SERVICE BULLETIN No.1192

COACH MODEL	: T2f 40, T2145, S2145, and C2045
BULLETIN TYPE	: Safety Recall Program
SECTION	: Section 3 - Drive Train
DATE	: September 1, 2006
SUBJECT	: Detroit Diesel NHTSA recall campaign #06E-019
TERMS & CONDITIONS	: Refer to Detroit Diesel Safety Recall Bulletin 06C-4, which has been attached to this Bulletin.

Subject: **Safety Recall 06C-4**
Series 60 Burst Logic

Baro Harness and Sensor

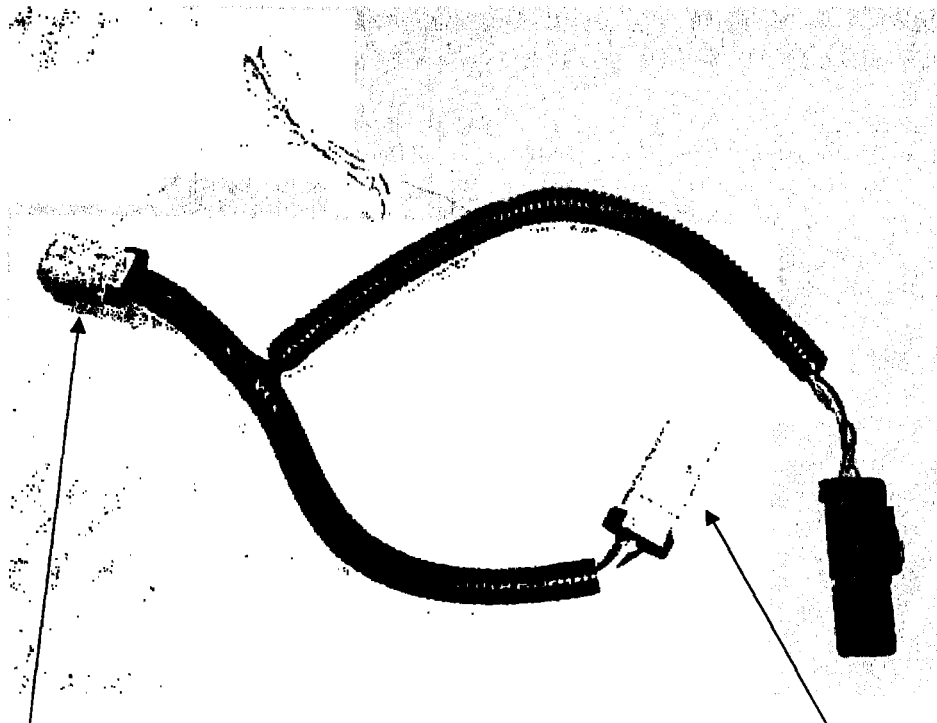
Compressor Wheel Burst Logic with Separate Baro Sensor

- **DDEC Feature Description**
- **This feature will aid in the detection of a failed turbocharger on the S60 diesel and natural gas engines.**
- **DDEC will monitor engine speed, load, air inlet pressure (natural gas) or turbo boost (diesel), barometric pressure, and the digital input for the parking brake.**

- **If the engine rpm increases due to driver power demand, and there is no significant increase in the intake manifold pressure, DDEC will turn on the CEL and SEL, log a hard fault turbo speed low (PID 103 FMI 1) and initiate a shutdown. This feature will be disabled if the parking brake is applied, as in the engine no load test.**

- **A turbocharger failure is detected when all of the following conditions are met:**
 - **Park brake is not active**
 - **Engine speed is greater than 1200 rpm**

- **Intake manifold pressure is less than barometric pressure**
 - **Load demand is greater than 30%**
 - **The failure condition has existed for .1 seconds**

- **Once these conditions have been meet, the following action will take place:**
- **Initiate shutdown to be overridden by stop engine override**

Connect to Turbo Boost Sensor

Connect to Sensor Harness Connector

Harness P/N 23536485
Sensor P/N 23527673
